Memorandum

To: Kahle Basin Redesign Project PAC
From: Meghan Kelly, P.E and Monica Grammenos, P.E.
Date: 10/7/2015
Re: Conceptual Design Plan and Project Update

**EXHIBIT 1
CONCEPTUAL LEVEL PLAN
KAHLE BASIN REDESIGN**

**Burke Creek/Rabe Meadow Master Plan
Kahle Basin Groundwater Elevation Augers**

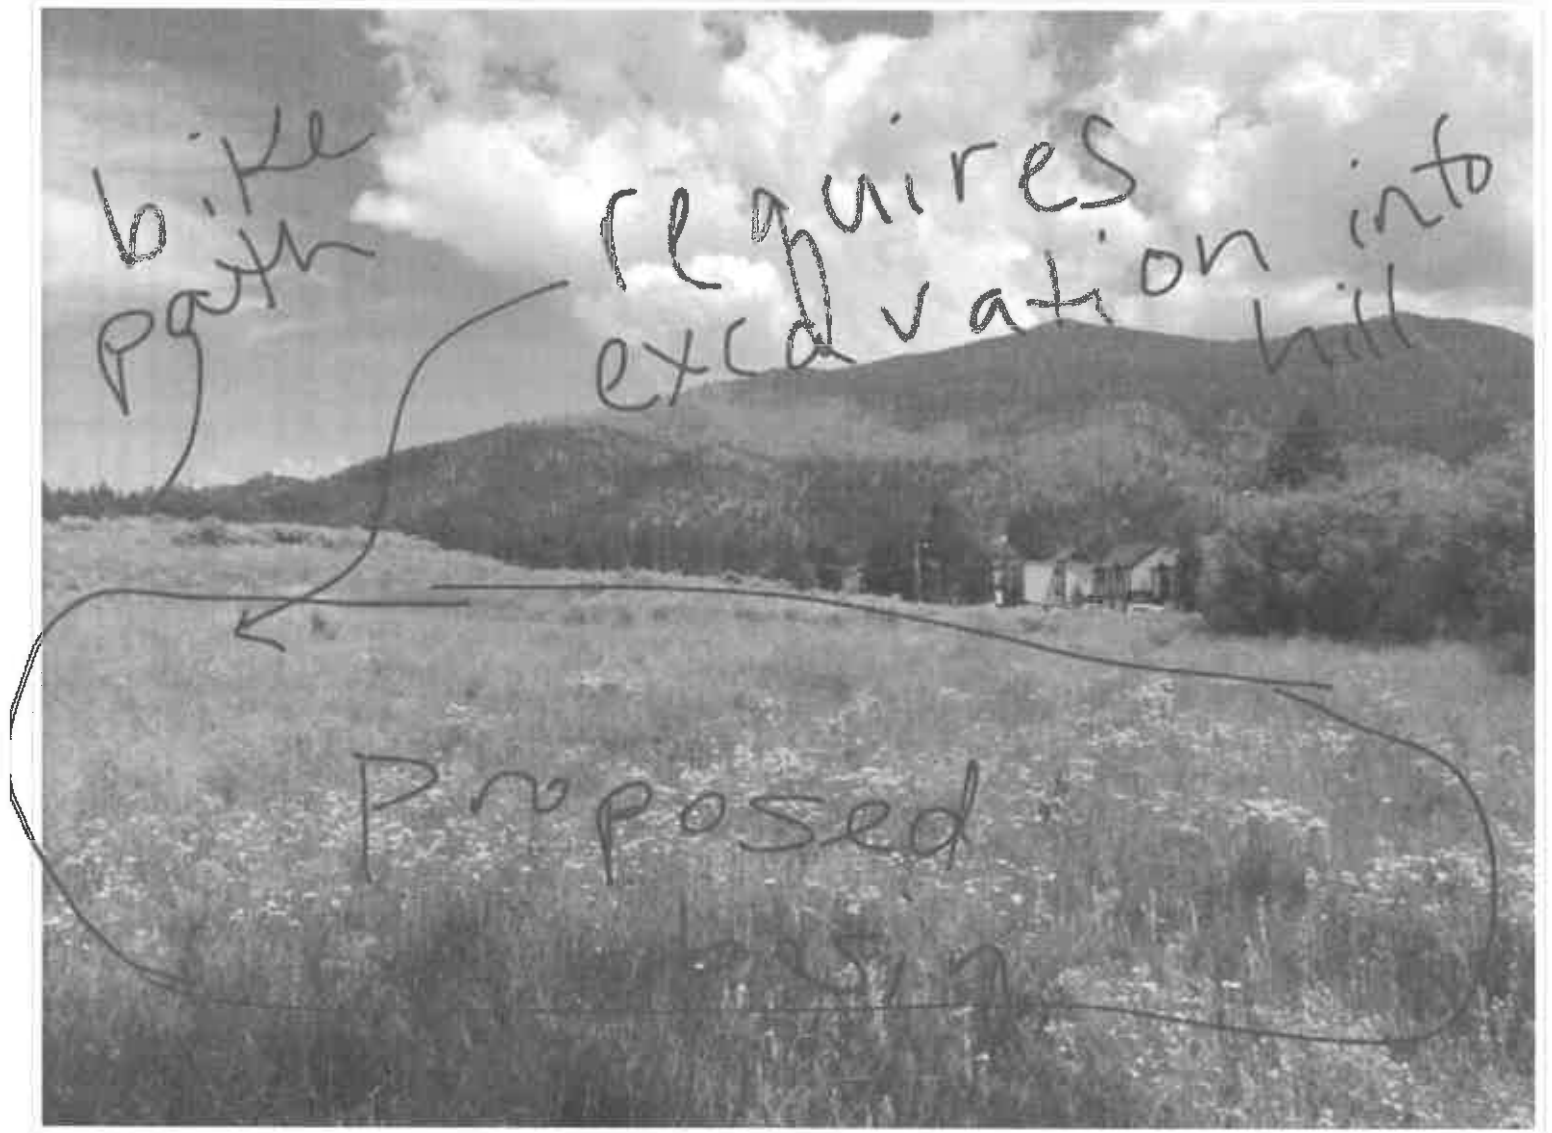
Several of us USFS service specialists met this AM to discuss and consolidate the feedback we have for the proposed Kahle Meadow Basin. We are all in agreement the basin location should be moved west of its current proposed location in order to avoid conflicts with the adjacent recreation trail. Please see the attached photos and NTCD map with comments from Rec Specialist, Ashley Sommer (Landscape Architect). She created these in the field on her I-Pad. Pretty slick! The team was in agreement with her recommendations.

- *The proposed location is in direct proximity to a major recreation trail and will be completely visible from a large portion of the Lam Watah meadow area. The project is also visible from some residential homes, as well.*
- *The bike path is located on the toe of the slope proposed for excavation*
- *The alternative location (shown on the attached) is screened from the residential area to the south by willows and is located far enough from the bike path that it is not visible due to topography and vegetation*
- *The topography of the alternative location is very flat and would require significantly less excavation and disturbance than the proposed location .*
- *The alternative location results in almost no effect to the recreation and scenic resources*

Visible from bike
path & residential

Alt. location -
Can't see from houses
or bike path - no
excavation in hillside

Proposed
basin - visible
from bike path

We recommend NTCDC create a map showing new proposed alternative in the recommended area indicated on the attached map. Please indicate again the sediment can location and conveyance into proposed pond, berm locations and maybe height.
